I. Correspondence with Lancashire County Council

From: Freeman, Paul <Paul.Freeman@lancashire.gov.uk>
Sent: 06 January 2022 15:09
To: Paul Bainbridge
Cc: Matthew Wright; Stephen Moorhouse; Eastham, Alan
Subject: RE: Lancashire Central Off Site Highway Works - Drainage details
Attachments: Pasco Basin Design.pdf; CLM12 Draft QSE uncontrolled 06.01.22.docx

TEMPORARY WATER COURSE DIVERSION & TEMPORARY DRAINAGE ROUNDABOUT STILLING BASIN

Project Title
CUERDEN SITE

Drawing Number
P1170-LCC-T01-DRG-002

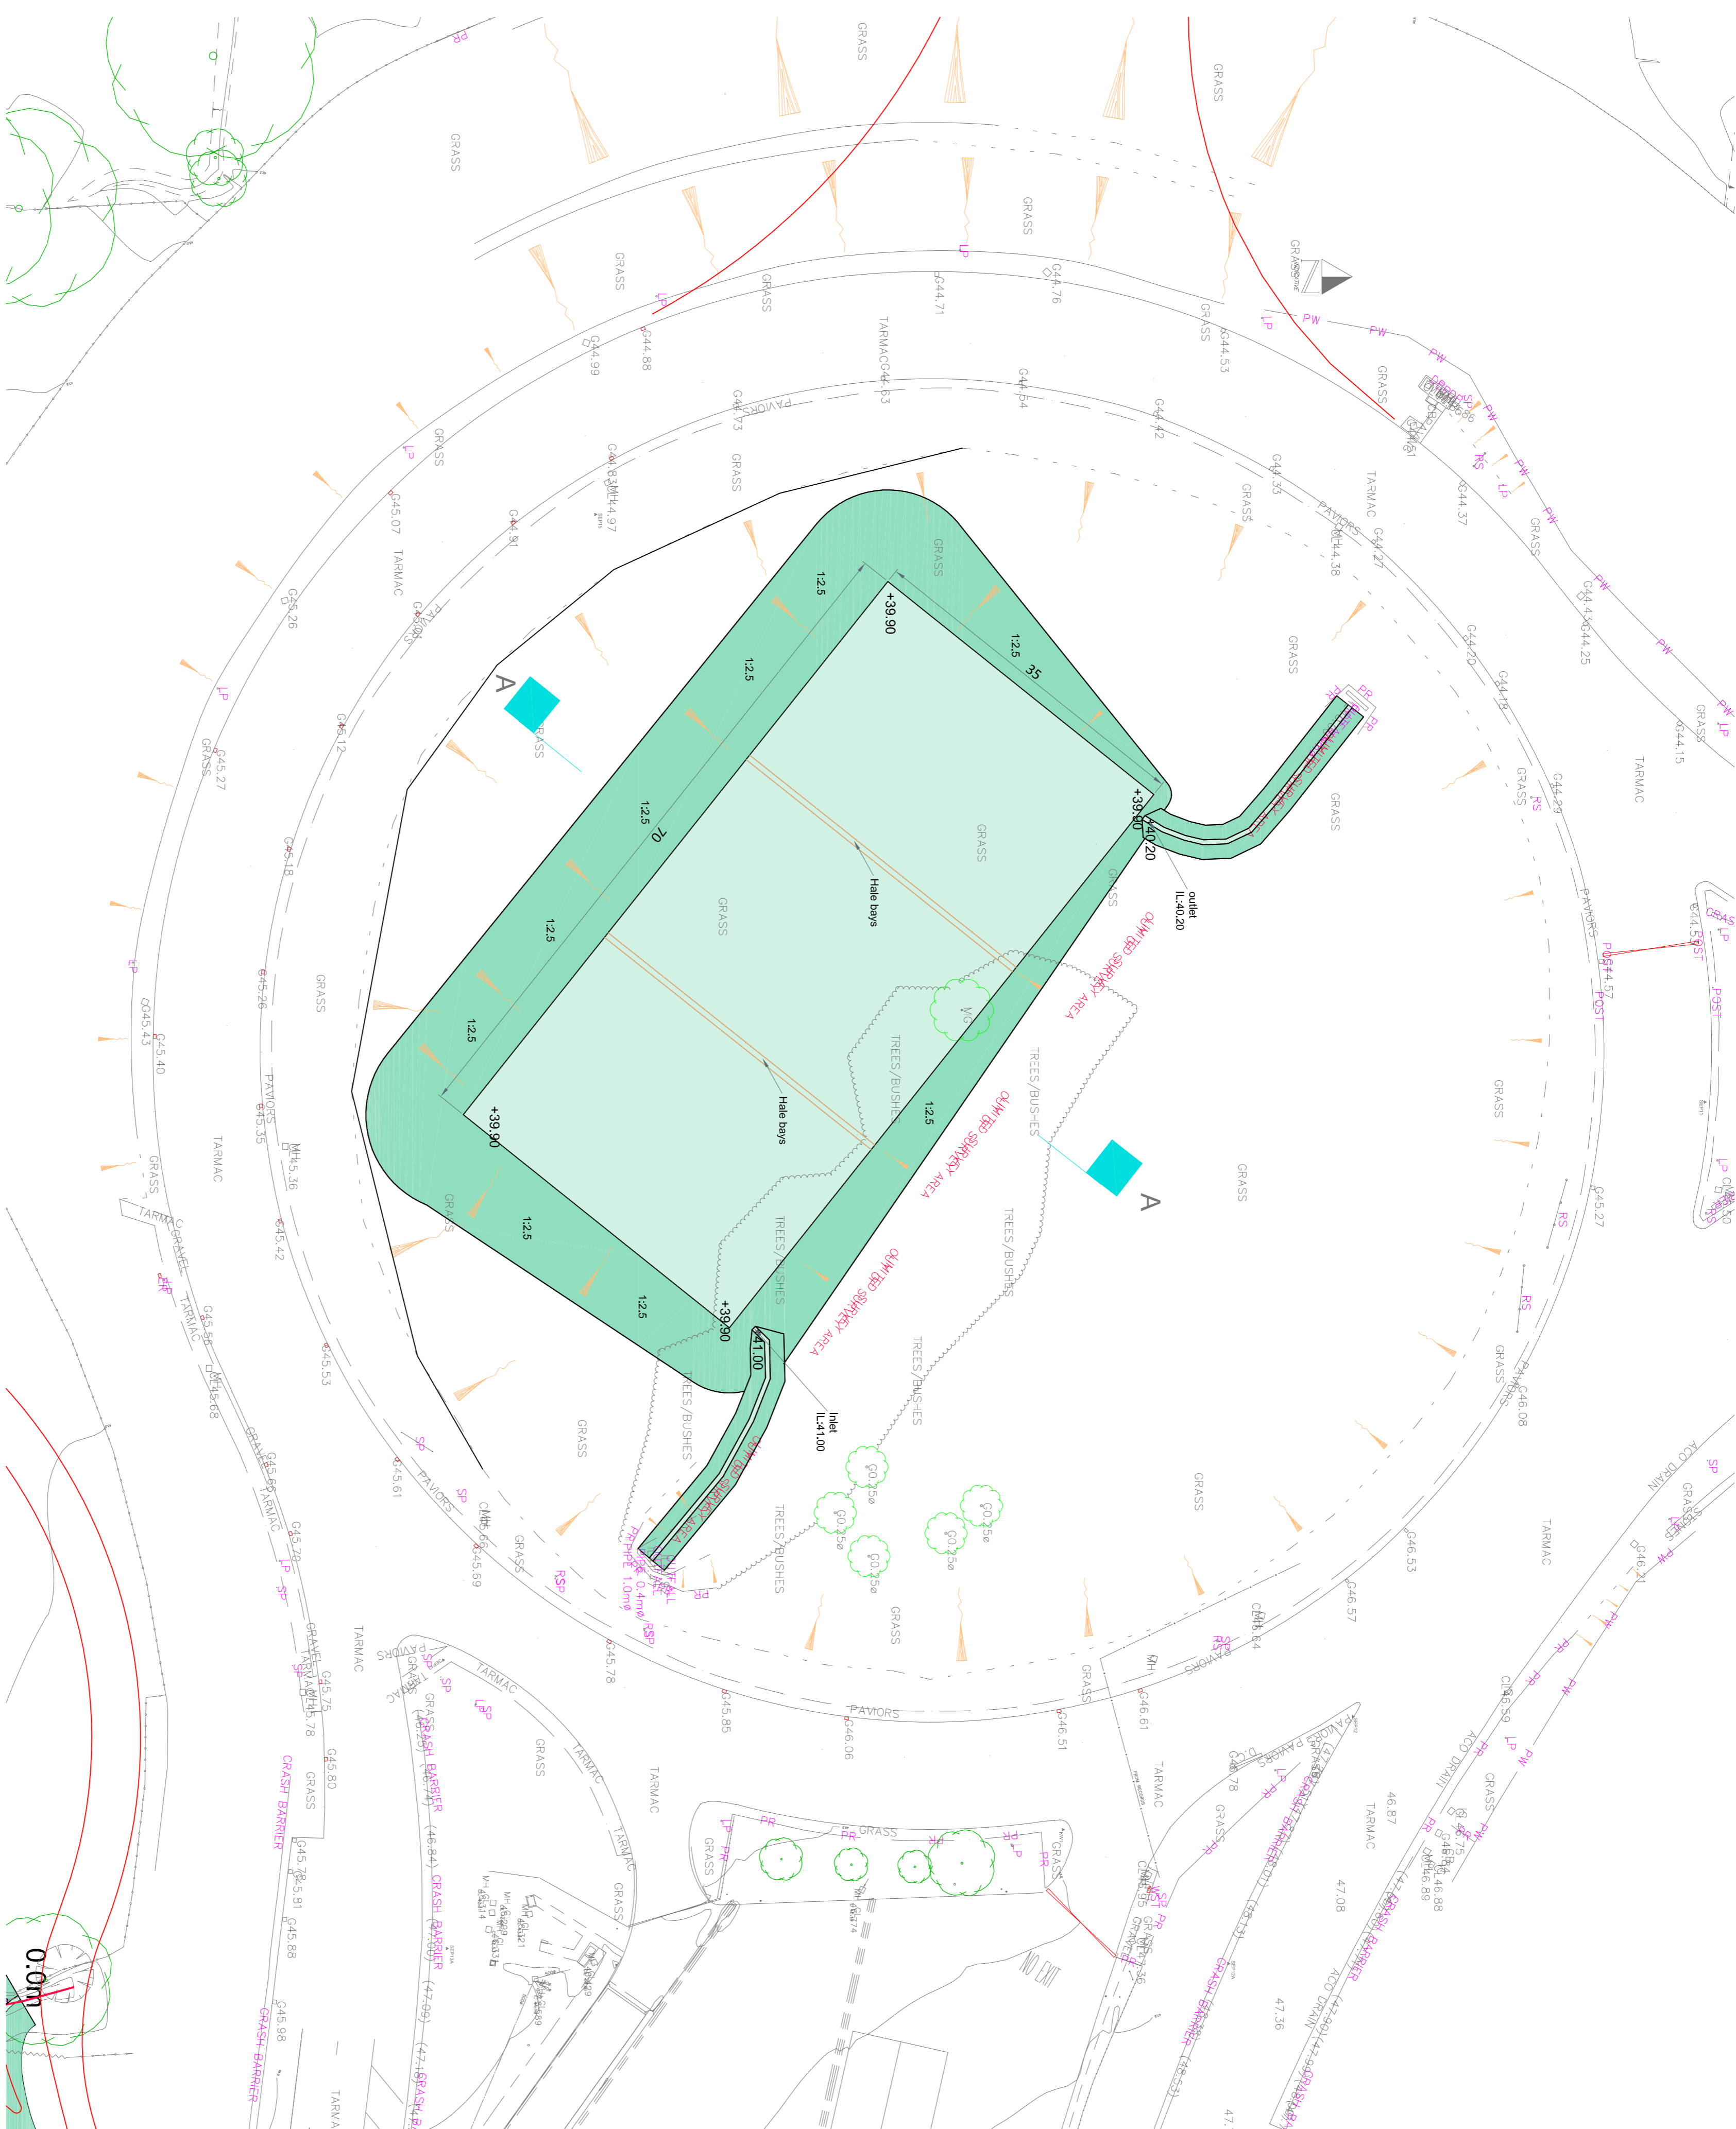
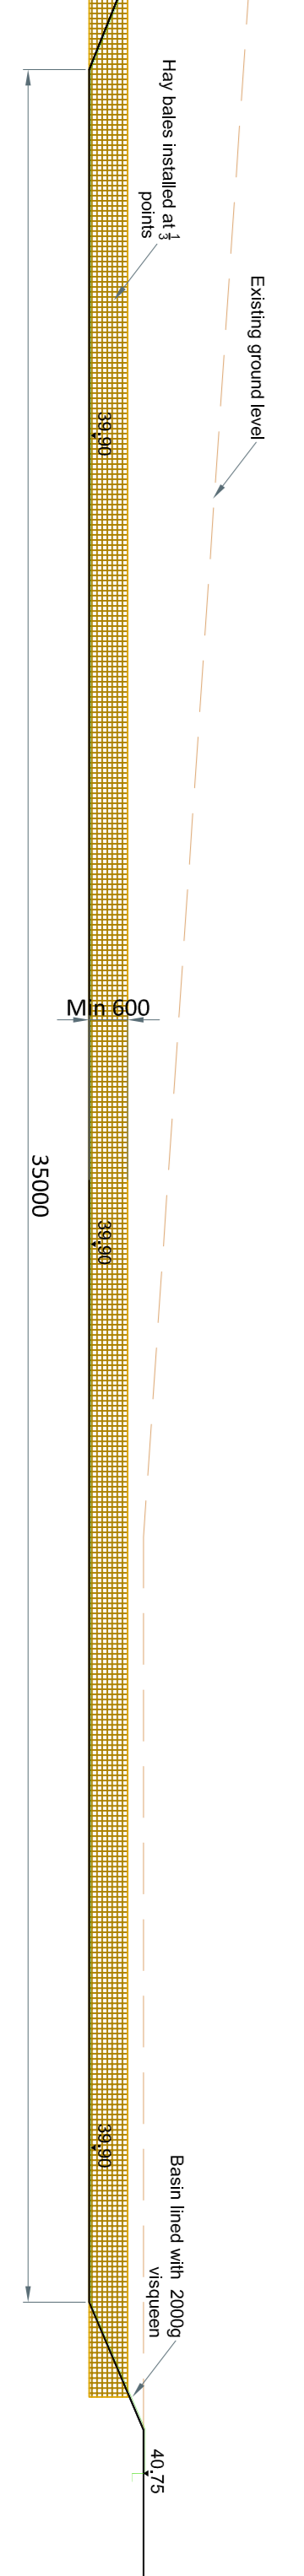
The basin currently has a maximum theoretical capacity of circa 1,900m³ at 1m deep as lined in its temporary works state, but we need to reduce this volume to provide a permanent water level, berm, topsoiling etc for treatment. I am confident that this can be achieved within that spare 35% capacity.

Permanently, we intend to install a hydro-brake within a chamber on the basin bank discharging back to the open channel prior to the upstream end of the western culvert.

We do not plan on surcharging the eastern culvert whilst attenuating, as we plan on using a riprap informal weir or similar erosion control matting to provide the inlet to the pond from the eastern culvert ditch; mimicking the previous bed level and cross-sectional profile at point of entry of the ditch rather than installing a restrictive piped inlet.

Furthermore, the design will ensure that the top water level in the attenuation pond will never exceed the pond inlet level during modelled storm events, achieved by way of a flow control bypass outlet which will be installed for exceptional events or for flow control malfunctions.
